From: Paul PBA <paul@pba-planning.co.uk>
Sent: 15 January 2025 12:28
To: Andy Watt
Cc: [REDACTED]
Subject: RE: DM/24/2957: The Prince Albert, Copthorne Bank, Copthorne, Crawley

Subject: DM/24/2957: The Prince Albert, Copthorne Bank, Copthorne, Crawley

I am writing on behalf of [REDACTED] of Balmoral, Brookhill Road, Copthorne, to express their concerns regarding the above planning application which includes a proposed apartment building opposite their property.

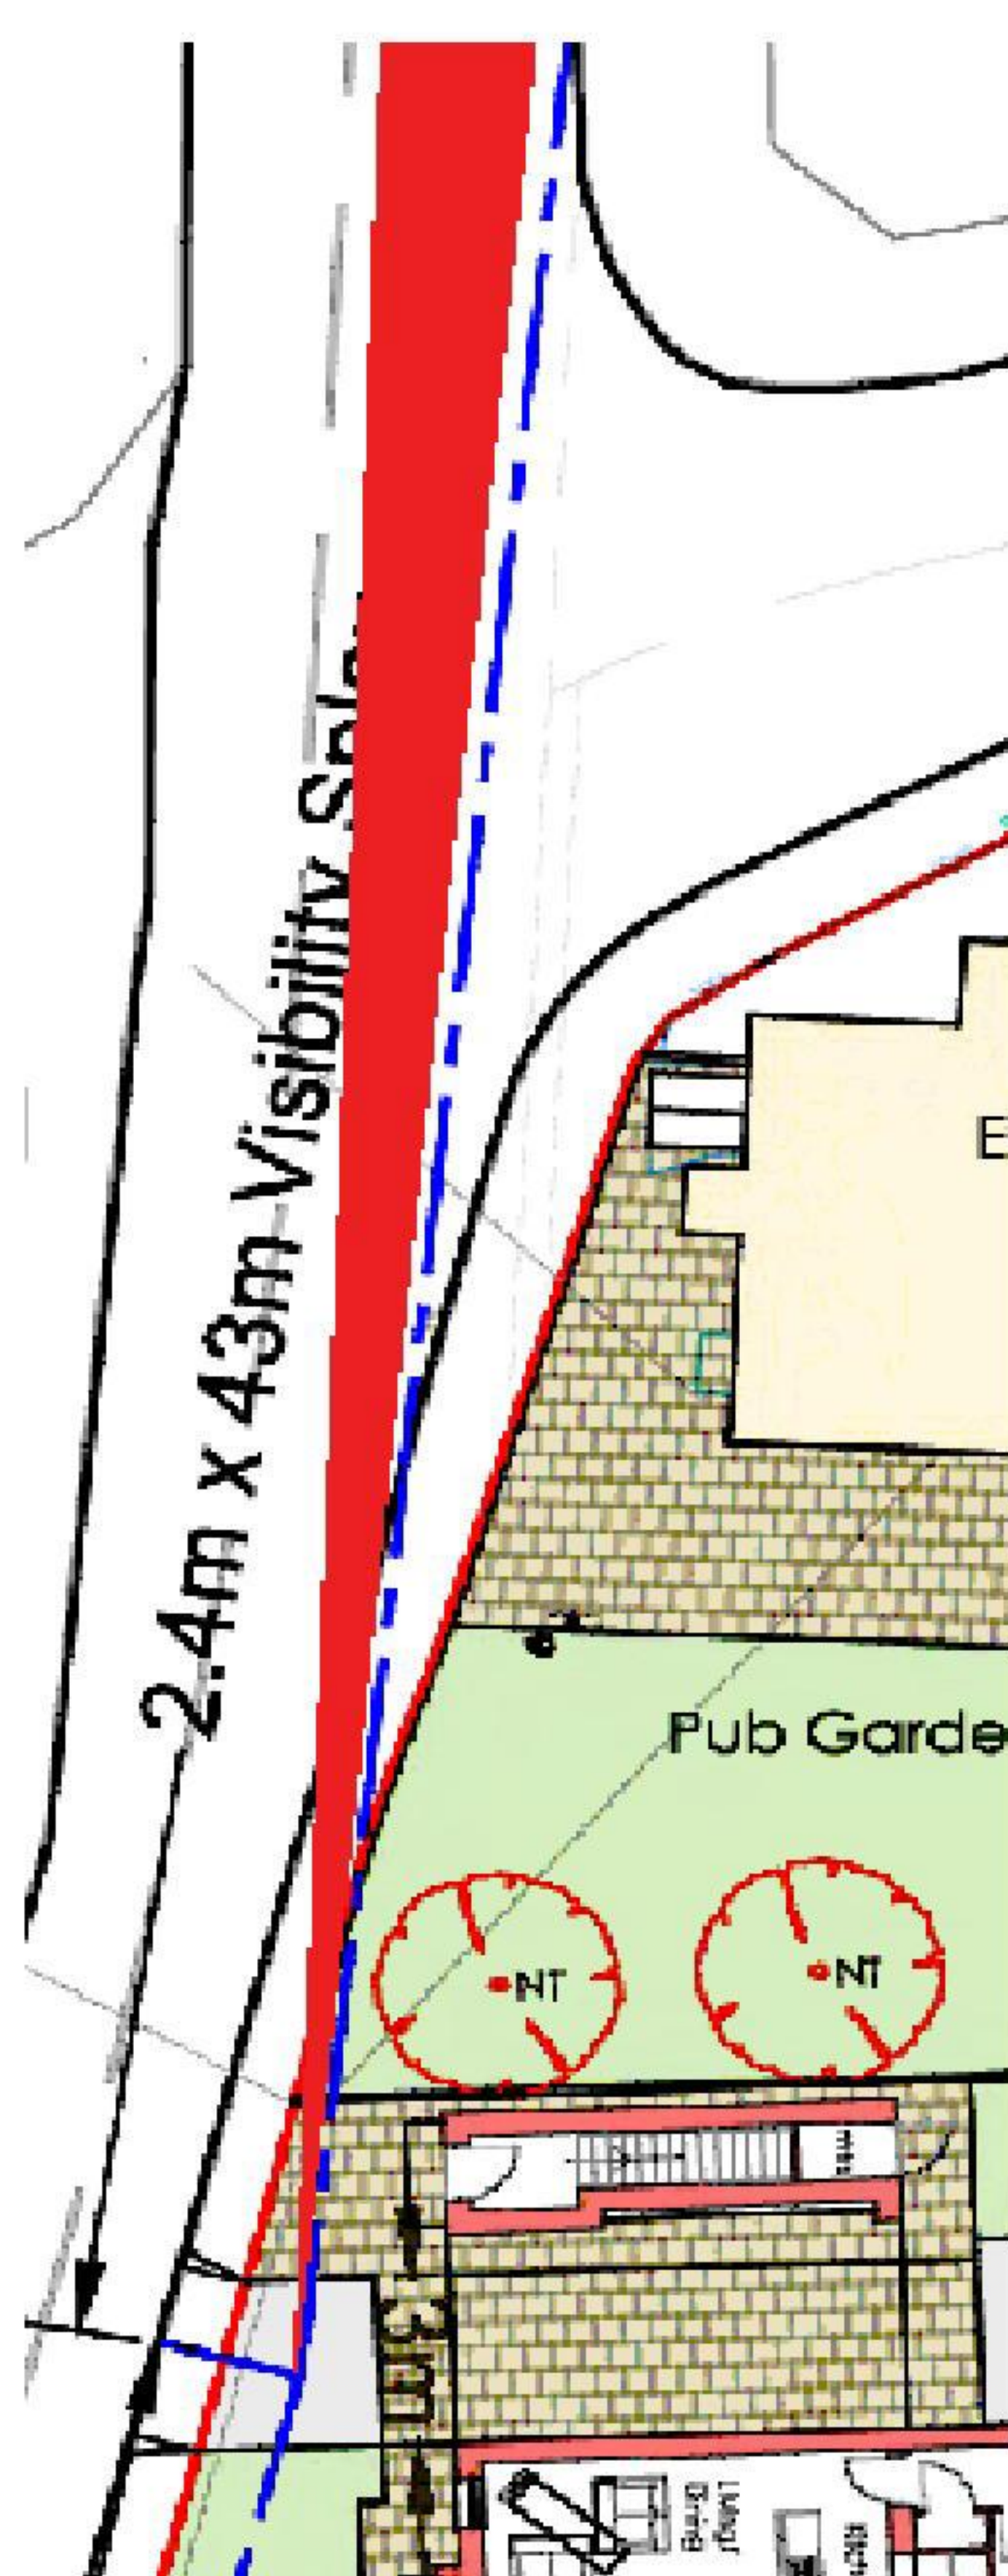
5. **Visibility Splays and Road Safety**
Section 4.2.3 of the Transport Report states, "Visibility splays from the residential access are shown within Appendix 3.2a. This plan shows that visibility splays of 2.4m x 43m are achievable to oncoming cars." However, the visibility splay plan appears to show an overhead electricity pole (marked as a small black circle):

The visibility splay is significantly compromised as shown below:

There is a risk to vehicles, but particularly to cyclists and motorcyclists, who may well be tracking closer to the kerb line.
